Hydro Tech Environmental, Corp.

**Re: VCP # 16CVCP011X
E-Designation # 16EHAZ014X
221 East 138th Street, Bronx, NY
Remedial Action Work Plan (RAWP) Stipulation List Addendum**

Appendix 1
Revised Foundation Plans

Appendix 2
Post-Demolition Soil and Trench Sampling and Endpoint Sampling Plan

FIGURE 5: PROPOSED POST-DEMOLITION SOIL PROBE, TRENCH & ENDPOINT LOCATIONS

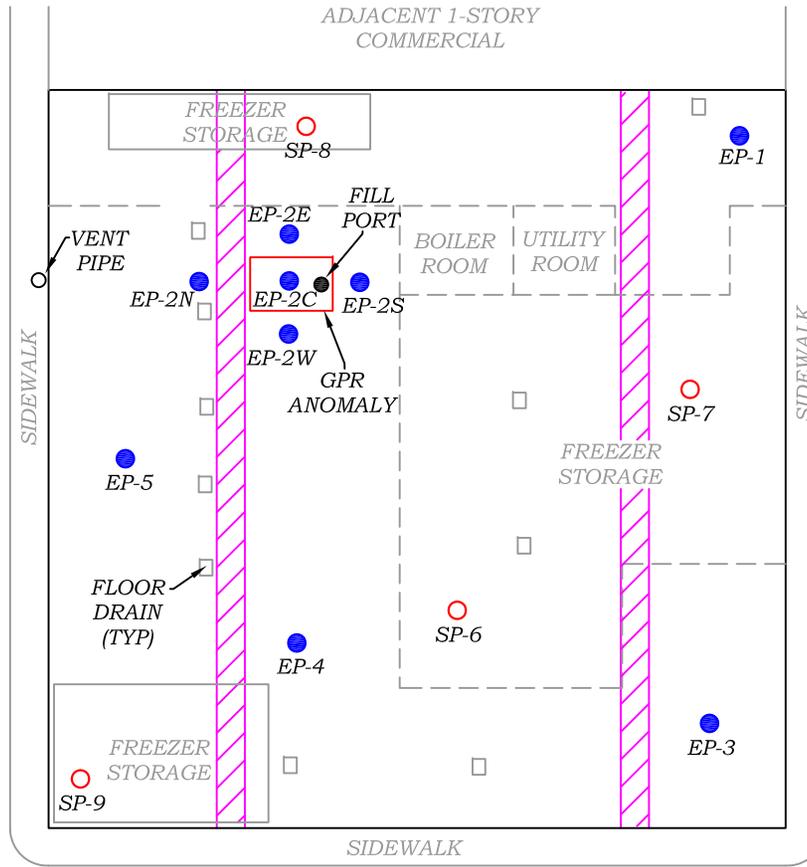
Perform additional site investigation to assess the presence of tanks and to further characterize the soil quality. Four (4) soil probes will be installed and eight (8) soil samples will be collected prior to the start of construction (after demolition). Two (2) trenches will be excavated to further investigate if there is any other tanks beneath the Site. A map indicating the location of post-demolition soil probes and trenched is attached in **Appendix 2**.

Collection and analysis of four (4) hotspot end-point samples from the bottom of the excavation and five (5) end-point samples from the bottom and sides of tank area to evaluate the performance of the remedy with respect to attainment of Track 4 SCOs. A map indicating end-point sampling locations is attached in **Appendix 2**. End-point samples will be analyzed for SCO trigger parameters. To evaluate attainment of Track 4 SCOs, analytes will include those for which SCOs have been developed determined by the analytical methods described above. If Track 1 Unrestricted Use SCOs are pursued, samples will be analyzed for VOCs, SVOCs, pesticides, PCBs and metals according to analytical methods.
